NAME OF PROJECT:  
CATHEDRAL HIGH SCHOOL  
4-PAC PORTABLE ADDITION  
LOCATION:  
30 Wentworth St N, Hamilton, ON L8L 8H5

ISSUED FOR ADDENDUM 2 2025-05-01

CATHEDRAL HS  
PROPOSED 4-PAC  
PORTABLE CLASSROOM  
ADDITION

SITE PLAN &  
OBC MATRIX

DRAWING:  
A1.00

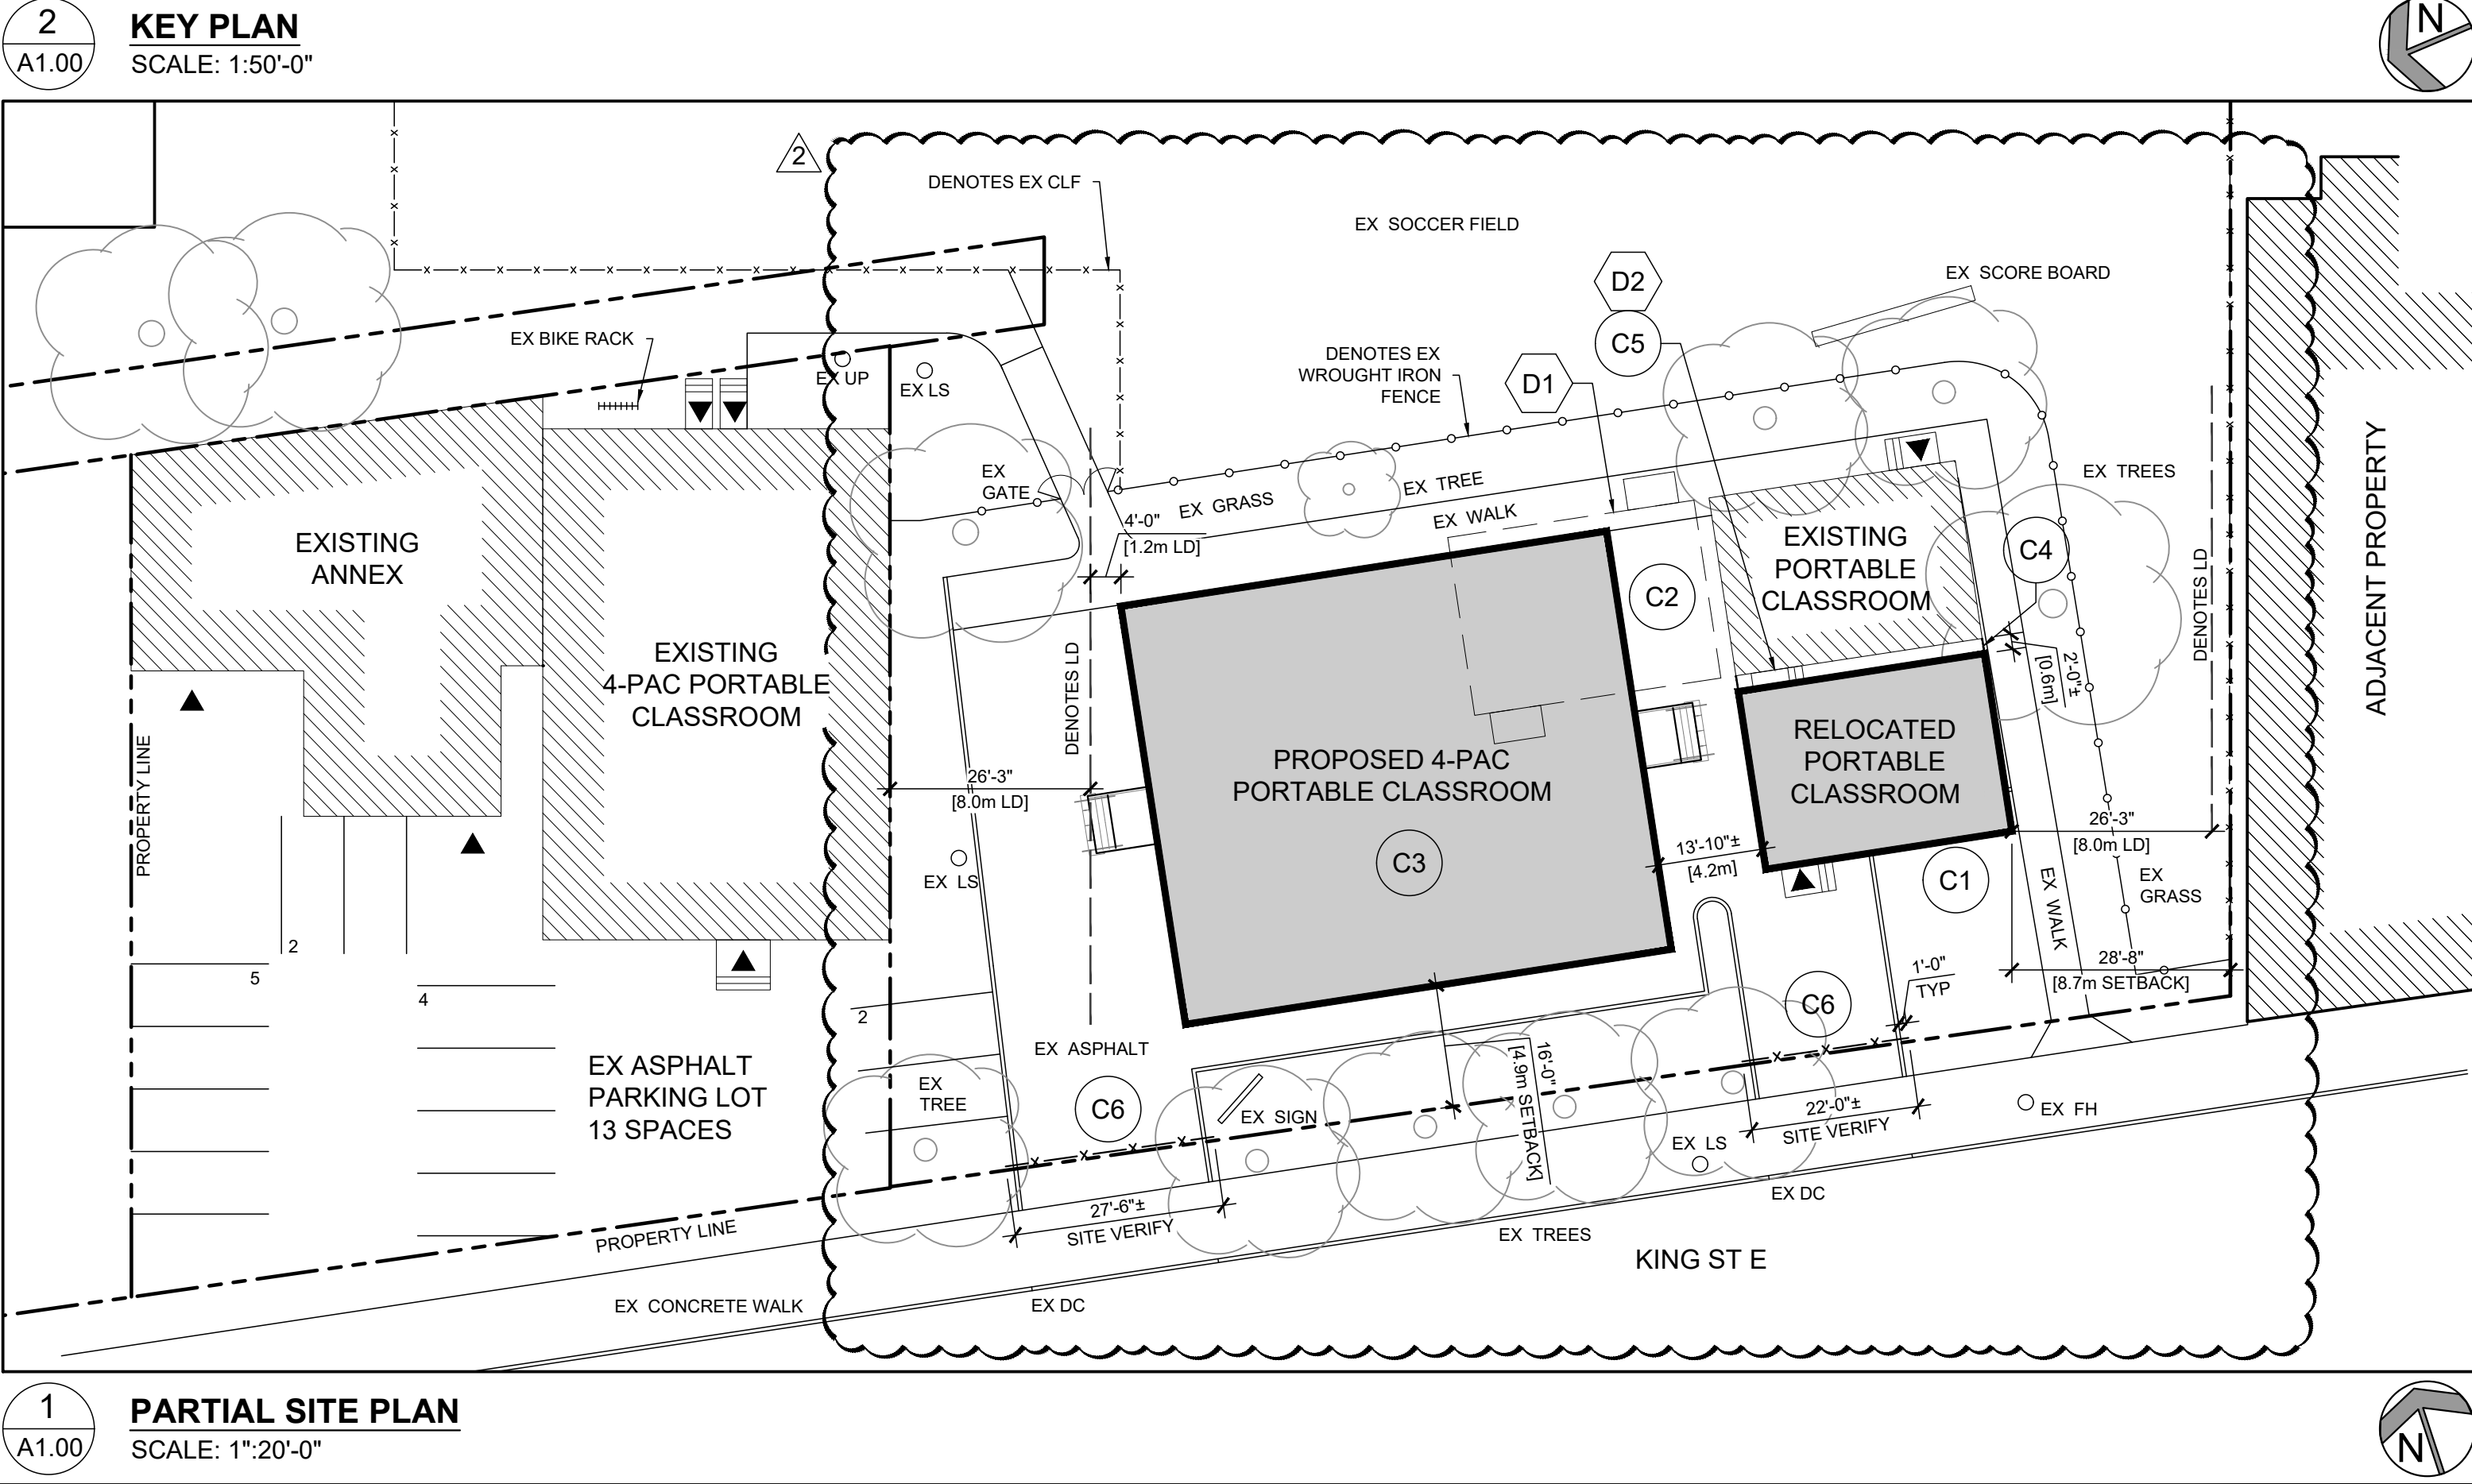
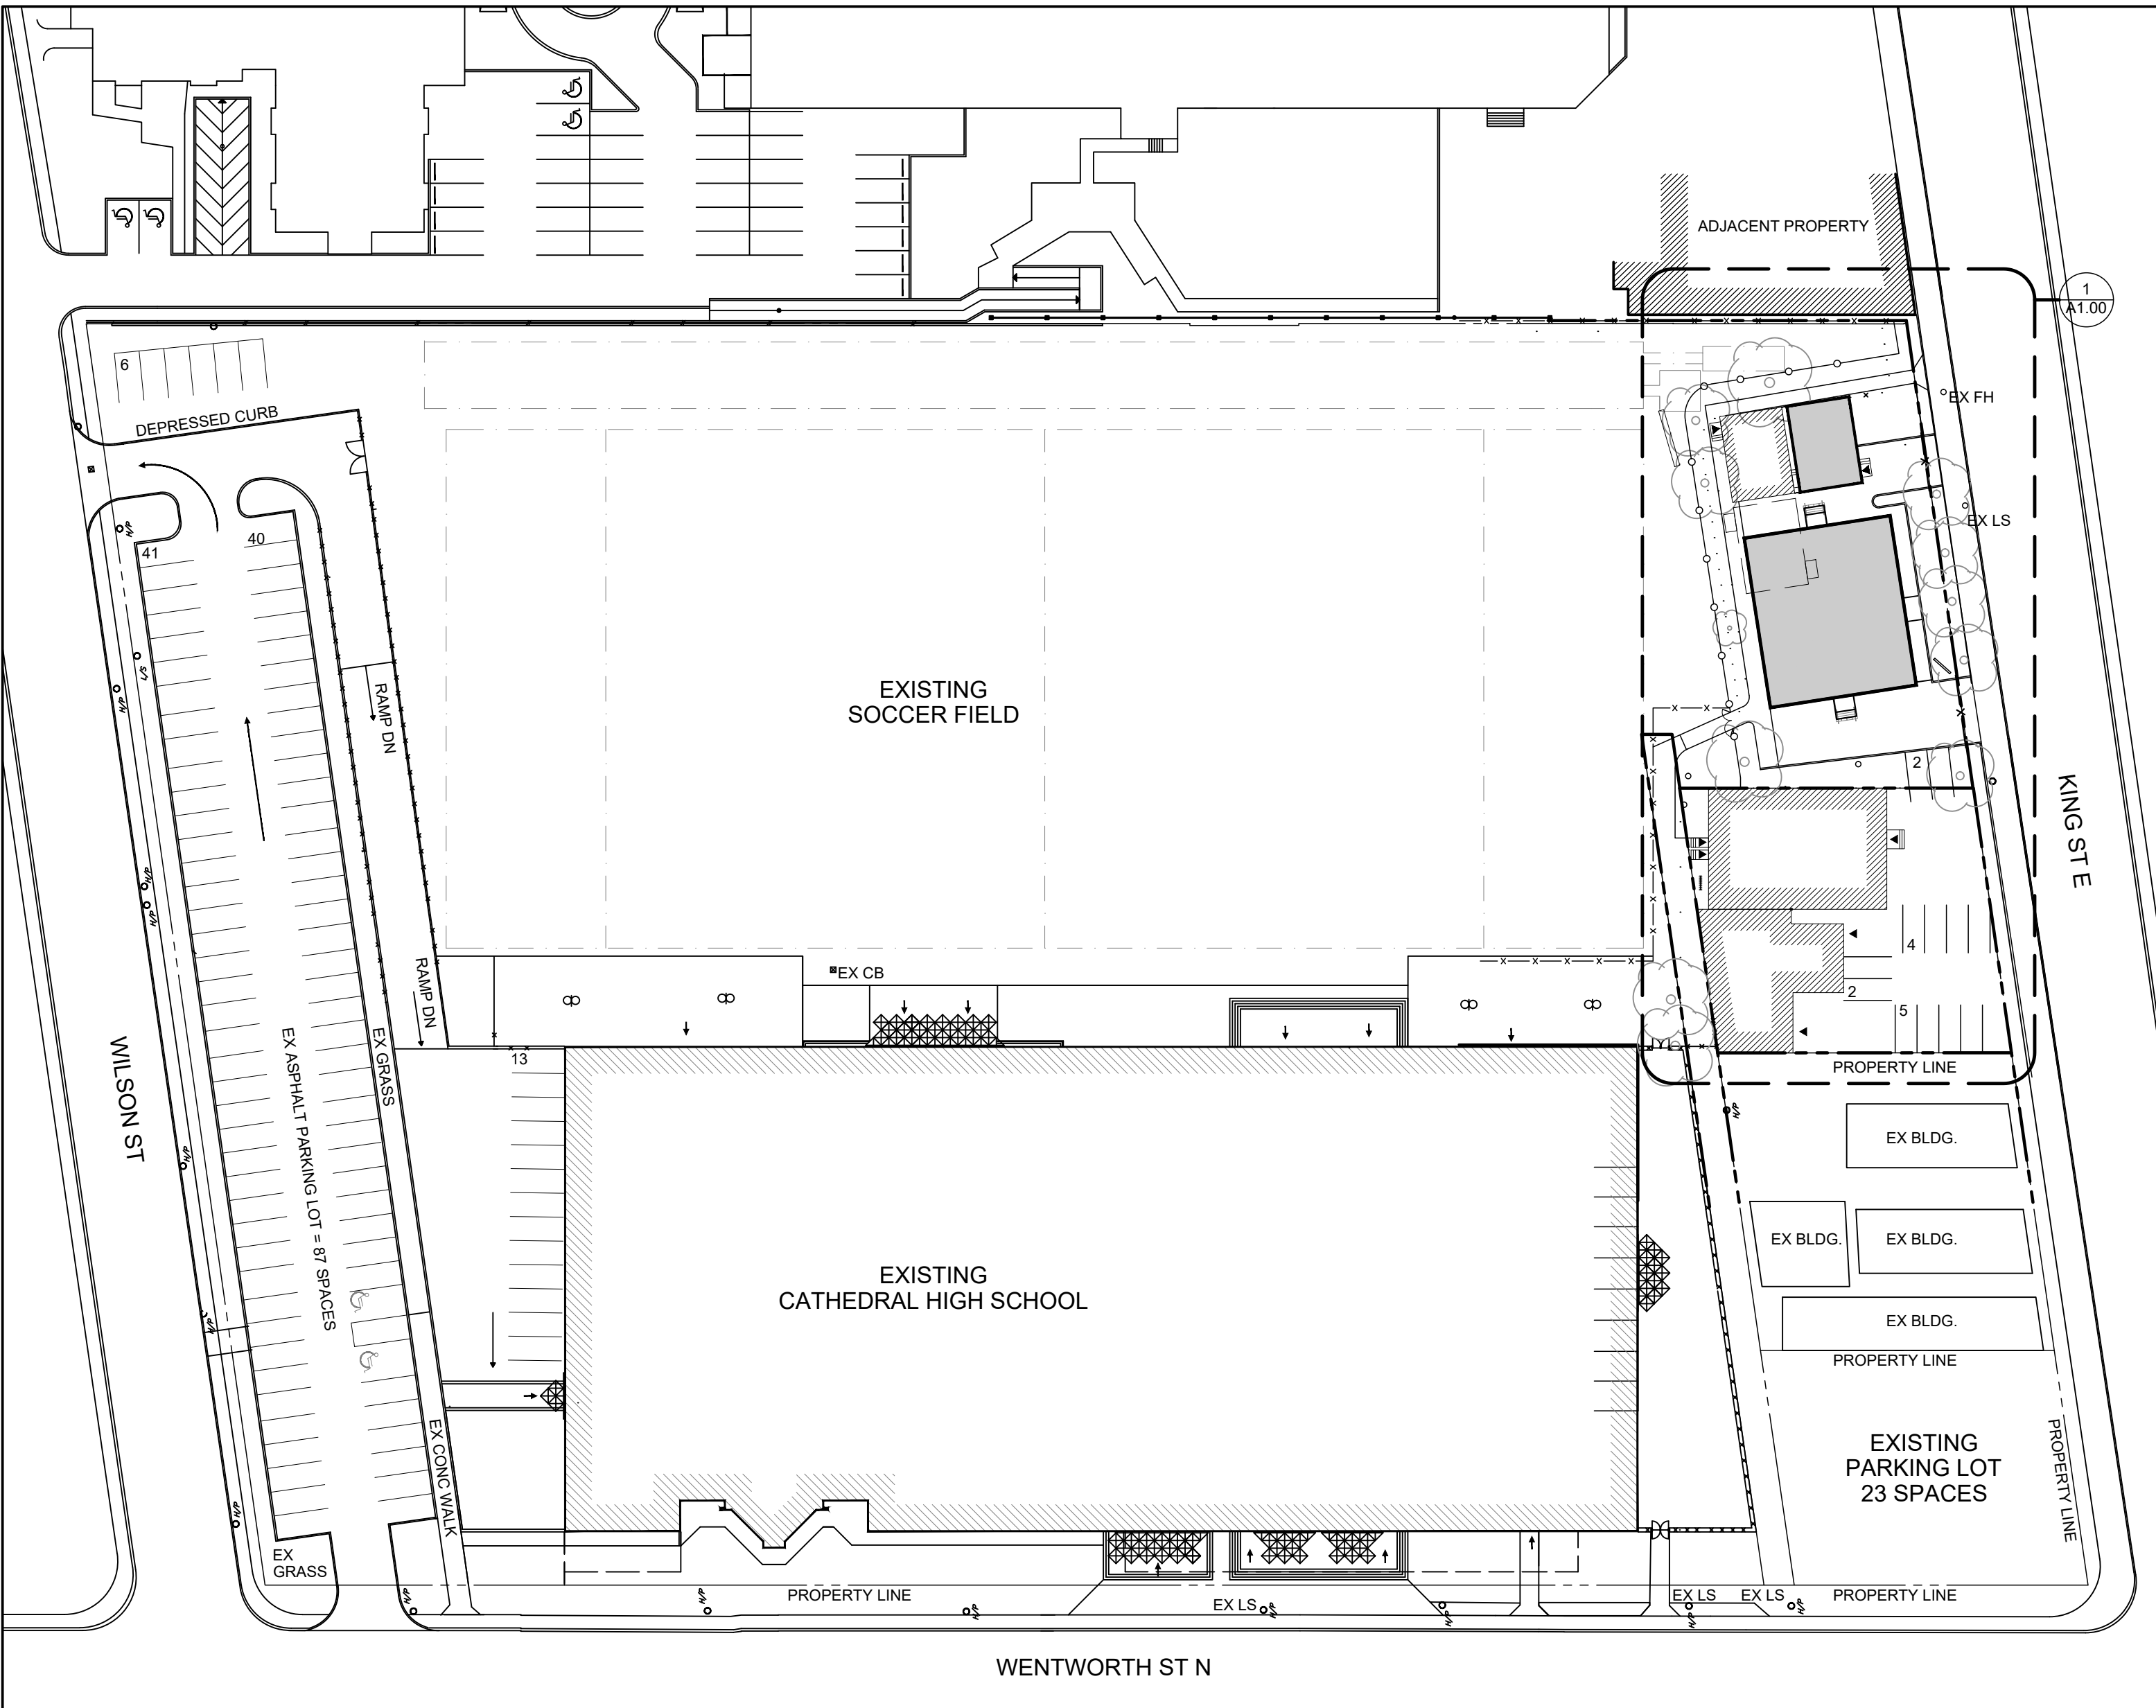
- Item 1**      **REVISE** Placement of Relocated Single Portable: as is shown on the attached revised drawing A1.00, Site plan and OBC Matrix, rotate the single portable 180 degrees and place up against the other existing portable to remain. This revision includes the addition of new wood stairs to replace the existing concrete stairs, and the removal of other redundant existing stairs. Refer to attached drawings A2.00 and A3.00 that form part of this addendum revision.

- C1 RELOCATE SINGLE PORTABLE TO NEW LOCATION ROTATE 180 DEGREES SO THAT WINDOWS FACE KING STREET COMPLETE WITH NEW WOOD STAIR AND HANDRAIL REFER TO A2.00 & A3.00 FOR RELATED DETAILS
